May 23, 2024

**Application for a Certificate of Public Convenience and Necessity for Approval
of the Fruitvale Substation Project (Application)**

Response to Vivian Lenardon (Lenardon) Information Request (IR) No. 1

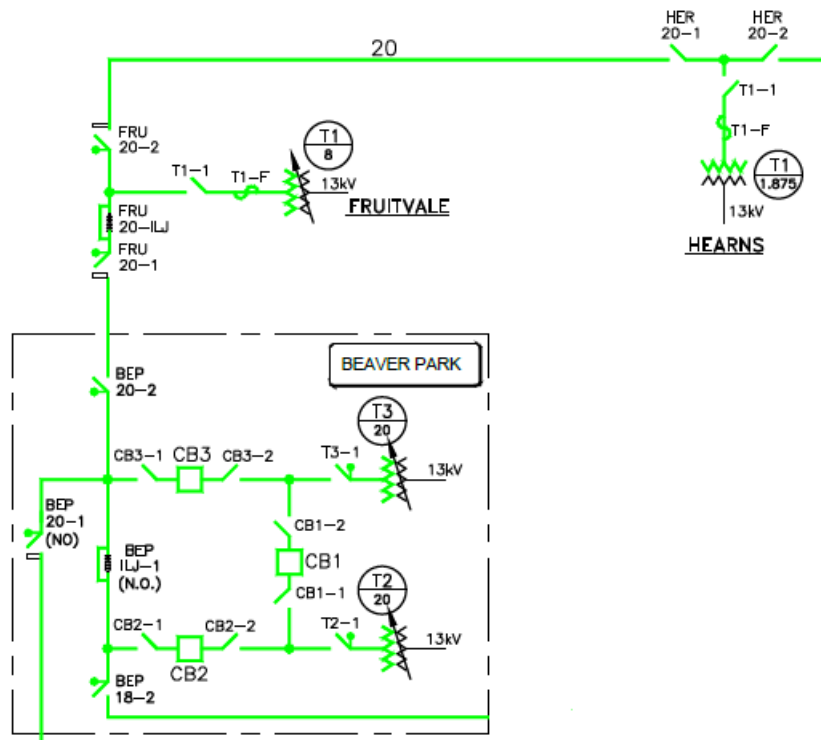
1. Single Line Diagram (SLD) of sub transmission system showing conductor sizes and substations on line.

The requested SLD is provided below. There are multiple different sections along 20L with different conductor types. When planning, the conductor with the lowest capacity (limiting conductor) is considered. The limiting conductor for both sections of 20L between Beaver Park/Fruitvale and Fruitvale/Hearns is 90 KCMIL CU.

Due to the fact that there are multiple different sections of conductor along 20L, it is not practical to show them all on a single line diagram.

1 **Figure 1: Magnetic Field Profile for the New Double Circuit Line that will Connect the Substation**
 2 **to the Existing Line on Old Salmo Road**

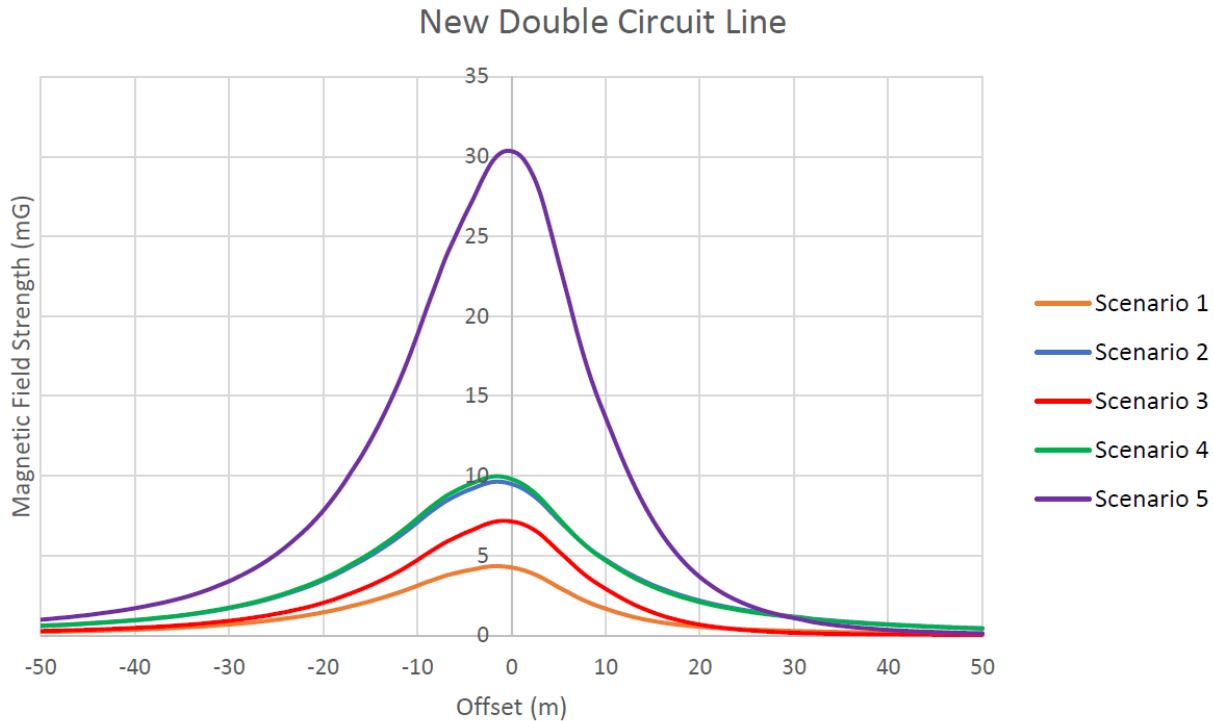
29. Please Provide EMF profile at max current, produced specifically for this project up to 40 m away showing reasonable precautionary measures away from adjacent property lines.

As shown in the below figure, the magnetic field levels are well below the exposure guidelines developed by the International Commission on Non-Ionizing Radiation Protection (ICNIRP), which

FBC has modeled five scenarios to show the EMF levels for the New FRU Substation power lines and the figure shows that even at the highest power levels for the lines, EMF levels are well below the exposure guidelines.
